# SERVICE BULLETIN

AMClassification: BT04-051	Reference: NTB05-017	Date: February 24, 2005
-------------------------------	-------------------------	----------------------------

## 2004 TITAN /ARMADA; FRONT LH/RH WINDOWS - RATTLE NOISE WHEN PARTIALLY OPENED

**APPLIED VEHICLE(S):** 2004 Titan (A60),  
2004 Armada (TA60)

Figure 1

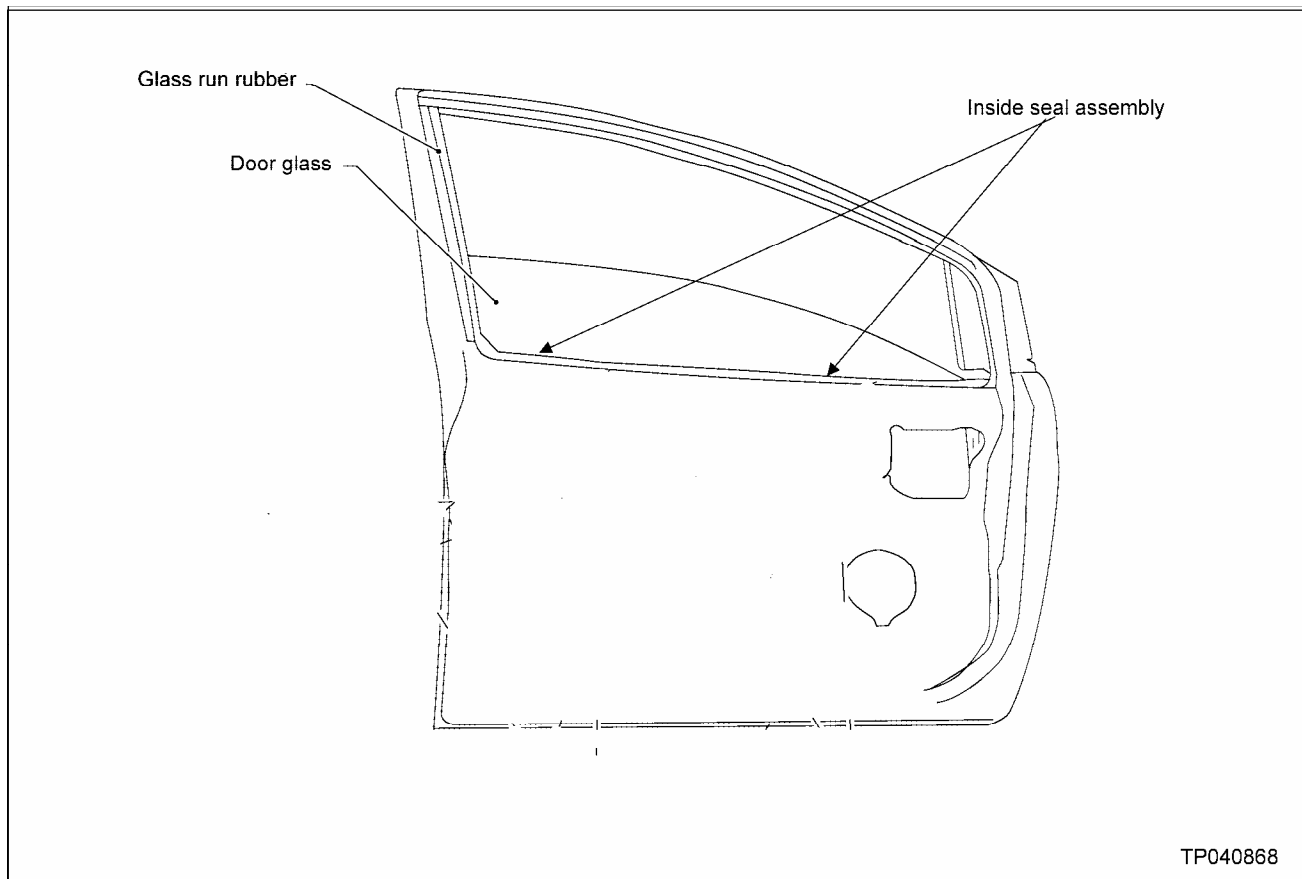
1. Remove the front door panel, as described/shown in the Service Manual Section EI.
2. Remove the front glass assembly, as described/shown in the Service Manual Section GW. (Figure 1)

3. Remove the glass run rubber assembly from the door (Figure 1).
  - Replace it with the glass run rubber assembly from the Parts Information section of this bulletin.
  - Make sure the glass run rubber assembly is installed correctly into the metal channels.
4. Re-install the door glass assembly.
  - Make sure glass fits properly into the run rubbers.
  - Perform all inspections and operations as shown in the GW Sections, including setting of the Limit Switch.
5. Reassemble the front door in the reverse order, replacing the old Inside seal assembly with the Inside seal assembly from the Parts Information section of this bulletin. (Figure 1)
